APPLICATION FOR MODIFICATION ASSESSMENT REPORT

Application Number:	Mod2020/0081
----------------------------	--------------

Responsible Officer:	Tony Collier
Land to be developed (Address):	Lot 1 DP 710661, 2 Delmar Parade DEE WHY NSW 2099
Proposed Development:	Modification of Development Consent DA2017/1183 granted for a Mixed Use Development comprising retail shops and shop top housing
Zoning:	Warringah LEP2011 - Land zoned B4 Mixed Use
Development Permissible:	Yes
Existing Use Rights:	No
Consent Authority:	Northern Beaches Council
Delegation Level:	DDP
Land and Environment Court Action:	No
Owner:	Margaret Mary Wells Simon Andrew Wykeham Wells Timothy William Wykeham Wells Peter Guilford Leonard Yvette Maree Leonard
Applicant:	Landmark Group Australia Pty Ltd

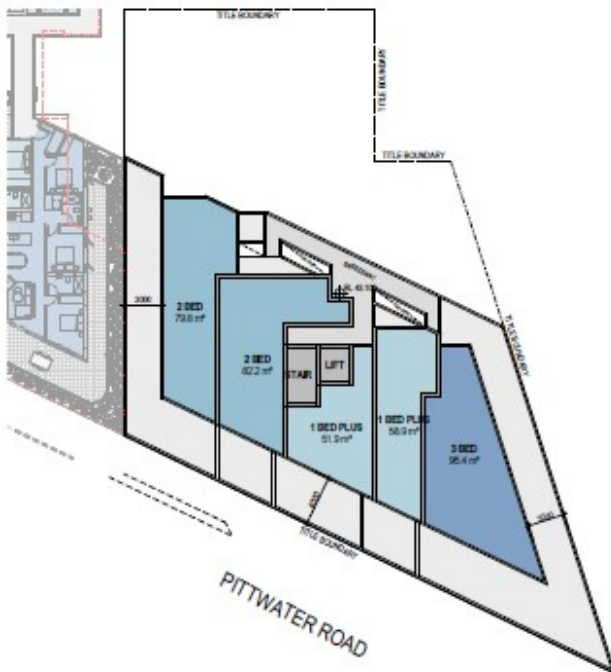
In respect of the reduced setback of the building on level 4 and above, the applicant should provide further documentary evidence that there is no increase in shadow impacts on our client's property as a result of moving the building closer to the southern boundary".

The setback of the south-facing wall to Levels 4, 5 and 6 abutting No. 816 Pittwater Road has been reduced from a variable distance of between 4.5m and 6.0m to 3.0m. With exception to the angled privacy screens which conceal narrow vertical profile windows to a bedroom, the wall is blank and therefore satisfies the Design Guidance under Clause 3F of the ADG.

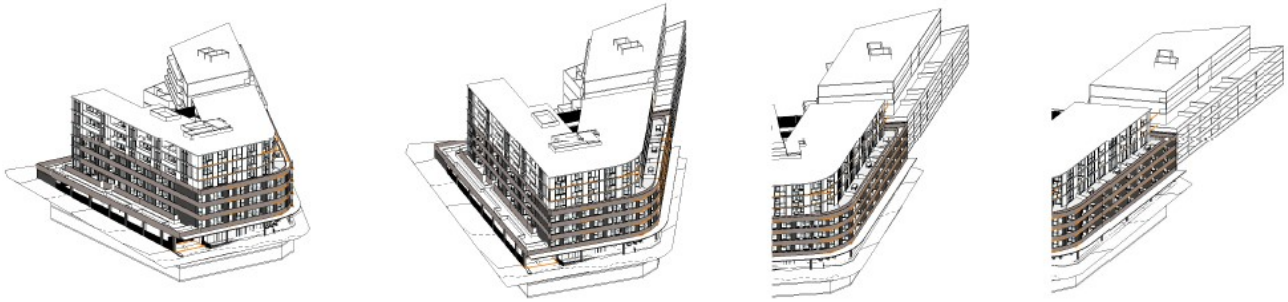
Notwithstanding, the applicant has provided concept plans for No. 816 Pittwater Road to demonstrate that No 816 Pittwater Road would not be prejudiced in its development potential and unreasonably impacted by the subject application. The figures below show the possible configuration of development at No. 816 Pittwater Road.
